RS-08-117

Braidwood Station, Units 1 and 2
Facility Operating License Nos. NPF-72 and NPF-77
NRC Docket Nos. STN 50-456 and STN 50-457

Byron Station, Units 1 and 2
Facility Operating License Nos. NPF-37 and NPF-66
NRC Docket Nos. STN 50-454 and STN 50-455

Subject: License Amendment Request to Adopt TSTF-490 Deletion of E Bar Definition and Revision to RCS Specific Activity Technical Specification

Figure 3.4.16-1 (page 1 of 1)
Reactor Coolant DOSE EQUIVALENT I-131 Specific Activity
Limit Versus Percent of RATED THERMAL POWER

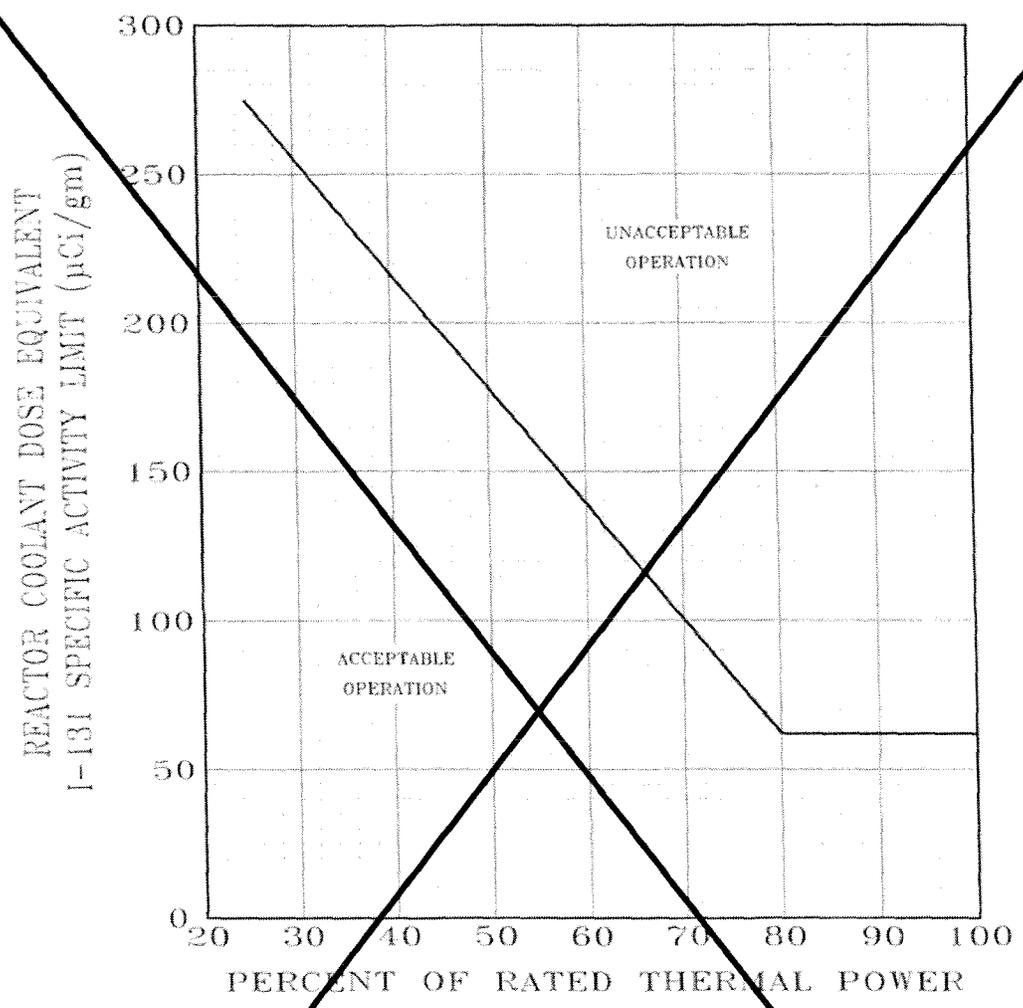
4. Revise LCO 3.4.16, "RCS Specific Activity," to delete references to gross specific activity; add limits for DOSE EQUIVALENT I-131 and DOSE EQUIVALENT Xe-133; and delete Figure 3.4.16-1, "Reactor Coolant DOSE EQUIVALENT I-131 Specific Activity Limit versus Percent of RATED THERMAL POWER."

5. Revise LCO 3.4.16 "APPLICABILITY" to specify the LCO is applicable in MODES 1, 2, 3, and 4.
6. Modify ACTIONS Table as follows:
 - A. Condition A is modified to delete the reference to Figure 3.4.16-1, and define an upper limit that is applicable at all power levels.
